# Proposed District Plan Submissions

## Form 5 Submission on publicly notified proposal for policy statement or plan, change or variation

Submission #272

##### Airport Drive Realignment Plan Submission – Neil and Lloma Hibell

### Structure Plan Guidance: Roading

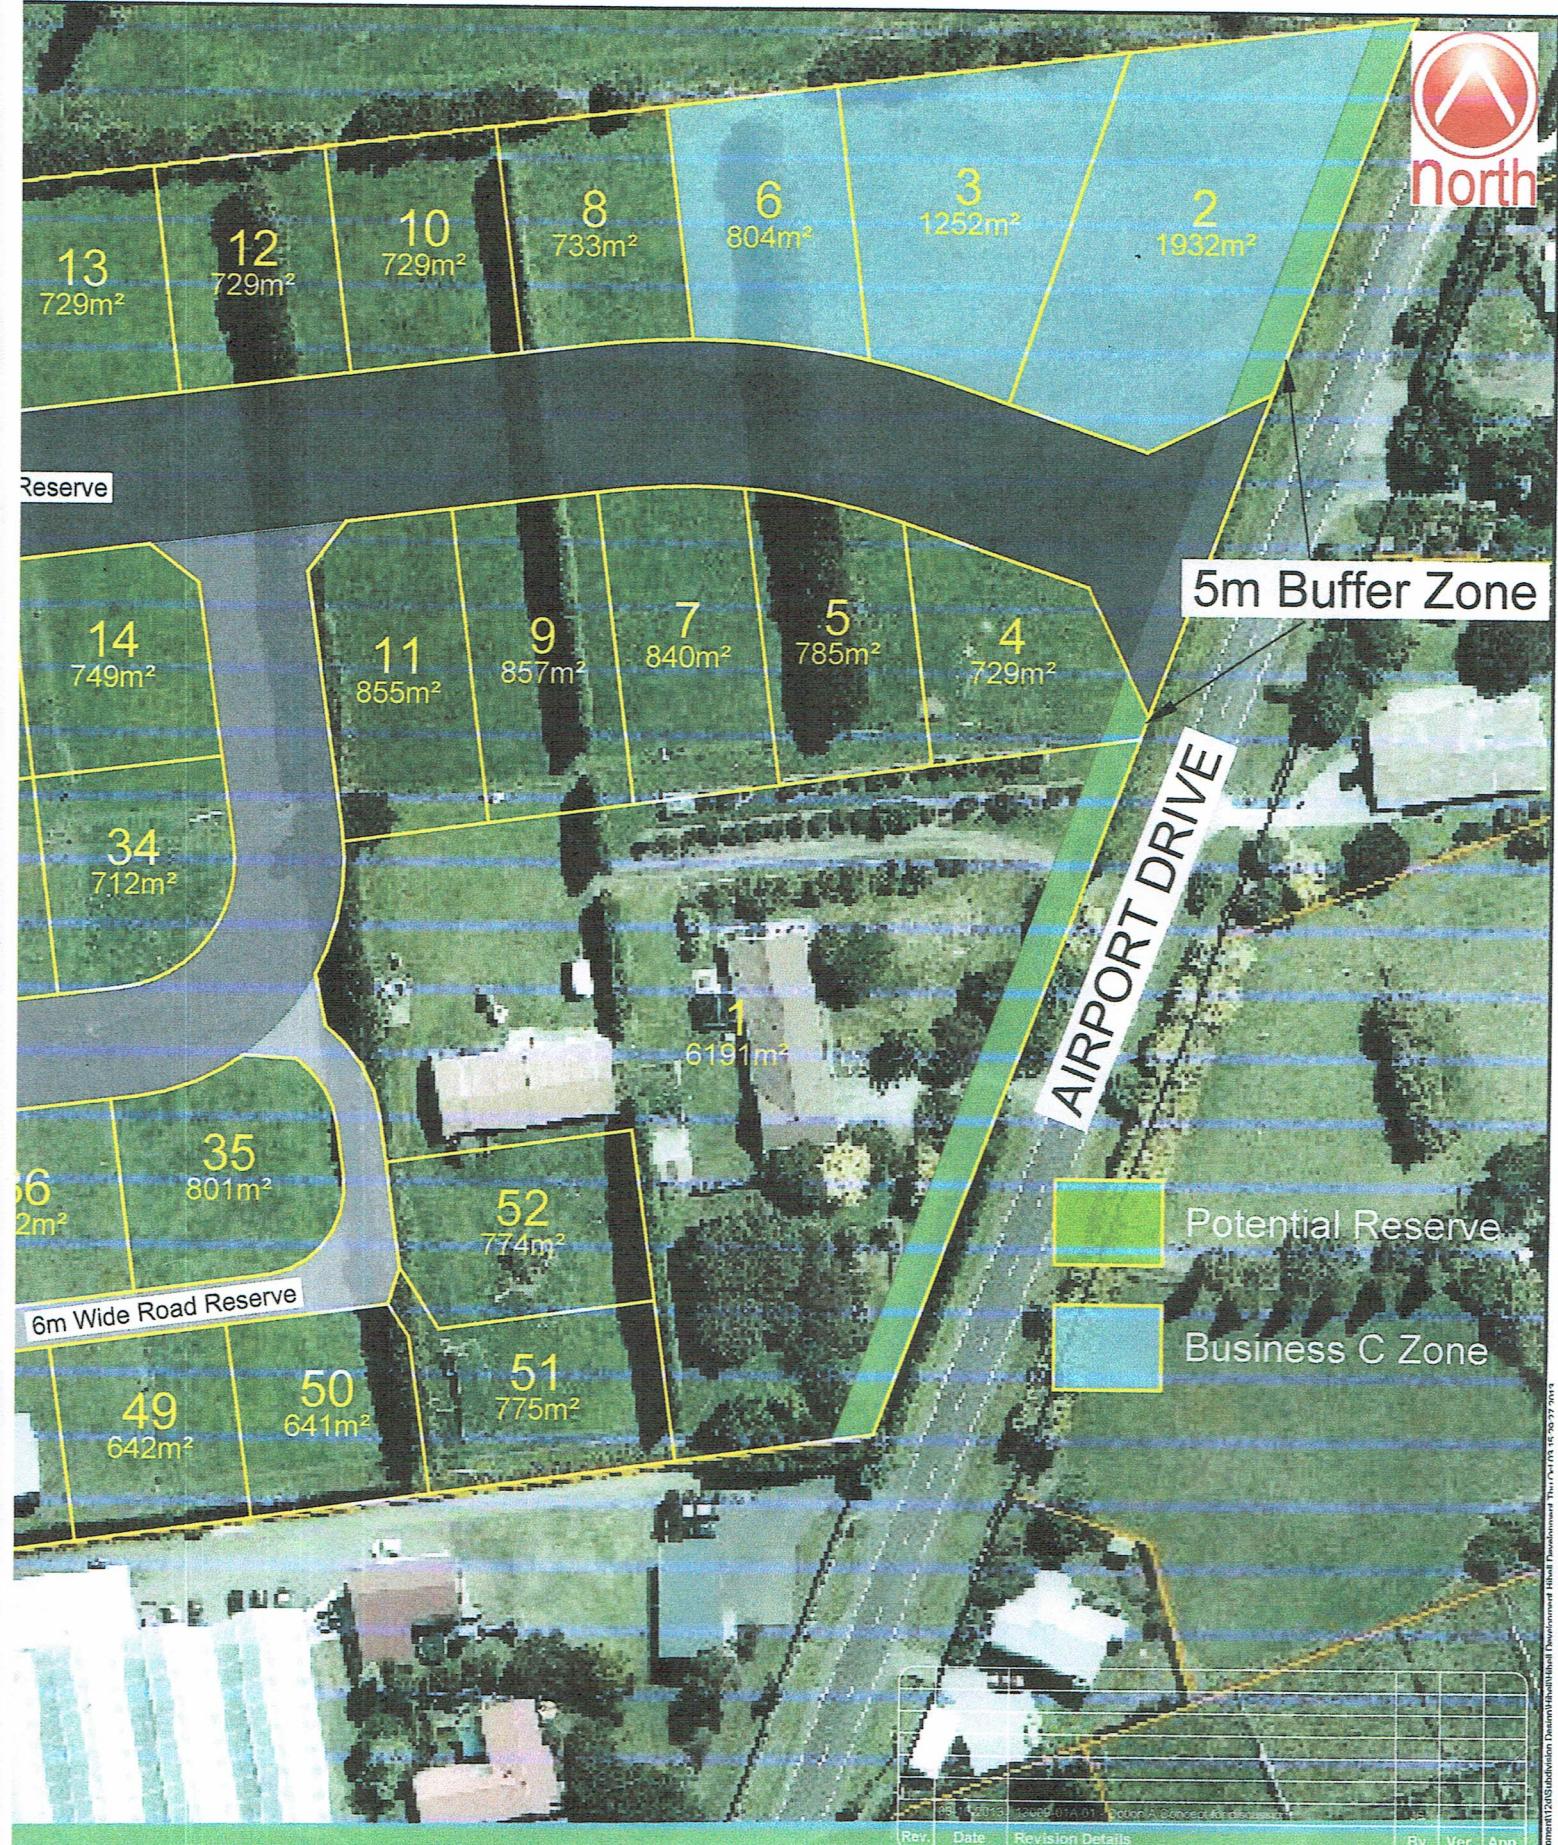
- Owners of 47 Airport Drive wish to re-confirm that they are firmly opposed to the proposal of the roundabout being located directly outside their home.

- Owners require written confirmation of the dimensions of roundabout. At a previous meeting with a planner it was discussed that the roundabout could be made smaller yet there appears nothing has been done to address this and we are now being told the boundaries have been set. No consideration or feedback was given regarding the previous request by the owners.

- Owners would like confirmation that the inconsistent boundary 'dog leg' beside roundabout nearest to 47 Airport Drive can be re-aligned to get rid of the 'dog-leg'. Justification for 'dog leg' is required otherwise.

- Request for the roundabout to be located as far away from 47 Airport Drive house as possible if proposed plan proceeds. We feel the roundabout could be moved further away from the house.

- Owners require written confirmation that the zoning for section number 2, 3, 6 (please see attached plans) will be classified as commercial. These plans have been presented on numerous occasions to council representatives yet nothing can be progressed.
- Written confirmation that there will be access to commercial sections 2,3,6 off Airport Drive not Parklands Ave extension
- Written confirmation that zoning for all other land will be classified as residential on attached subdivision plan

- Owners would like confirmation that area Q local road has the ability for a right turn on to Airport Drive Realignment Road when exiting 47 Airport Drive. Do not want to have to turn left and travel around the roundabout to travel north.

1. To move roundabout away from 47 Airport Drive house (further up the road)
2. For the council to actually consult and listen to the concerns of the owners of 47 Airport Drive
3. There to be clear and active communication with residents and the councils project management team - this has not been done so far
4. For area Q to be classified as residential land including 47 Airport Drive
